SUBMISSION TO NSW DEPARTMENT OF PLANNING & ENVIRONMENT ON INGLESIDE DRAFT STRATEGY AND DRAFT TECHNICAL STUDIES

28 February 2017

Comments on the Draft Structure Plan

Submitted by Tony Edye & Associates Pty Ltd
Principal: Tony Edye B.Arch (Hons) AIA
Registered Architect Registration No. 4542

Ingleside (Old Mona Vale Road) Bypass Proposal

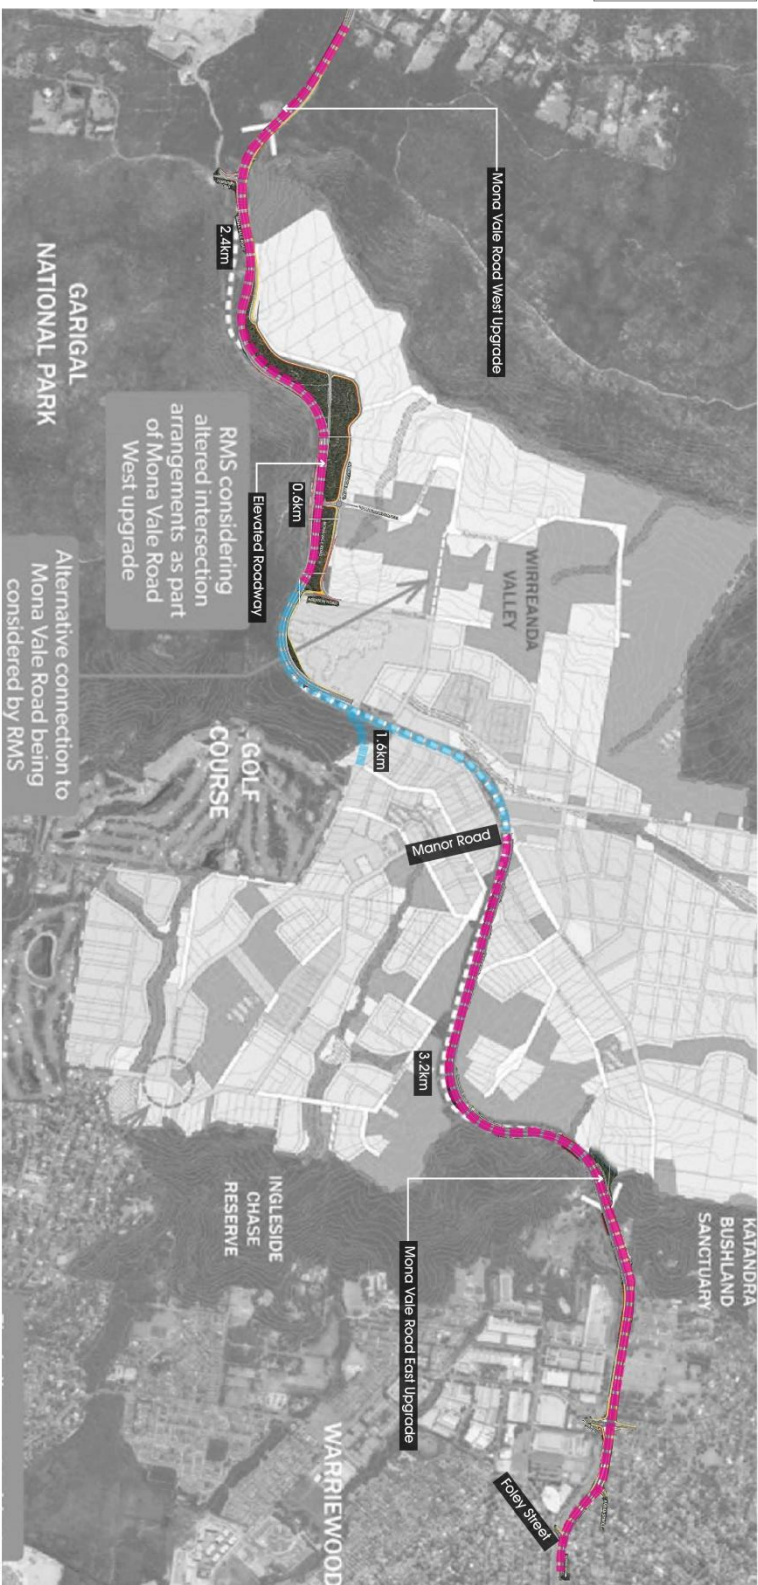
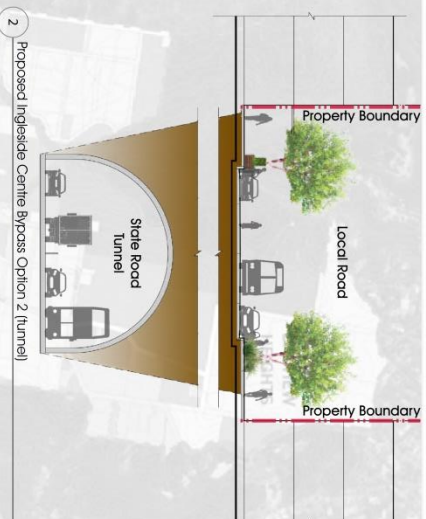
1 Mona Vale Rd/Lane Cove Rd/ Manor Rd intersection

Mona Vale Rd is proposed to be widened to four lanes for the full length of the road between the Samuel St. roundabout and Lane Cove Rd, and the Bahai Temple and Kimbriki Tip turnoff.

This upgrade will increase traffic numbers until they catch up with current congestion levels and it places a major highway through the centre of a new suburb.

The solution presented is for one point of exit to and from Mona Vale Rd for north and south Ingleside which is already overloaded.

The result of this will be that pedestrians wanting to gain access from south to north Ingleside and vice versa will have to do this via a pedestrian crossing, use of which will regularly stop traffic in both directions. This will cause added pollution, frustrated drivers and danger to pedestrians. This is surely not sustainable.

We recommend the construction of an overpass or underpass for pedestrians at this intersection to alleviate this unsustainable activity. It may be considered that a grade separated vehicle crossing would be an advantage as well.

A sketch design of such a crossing is found at the Appendix on p11.

1. Old world wide road becomes village main street' with 2 lanes + parallel parking both sides.
2. Improved connectivity between Ingle side north and south; wildlife corridors, bicycle, pedestrian, (walkability & livability).
3. Reduction of 'on-street' road infrastructure and setback requirements.
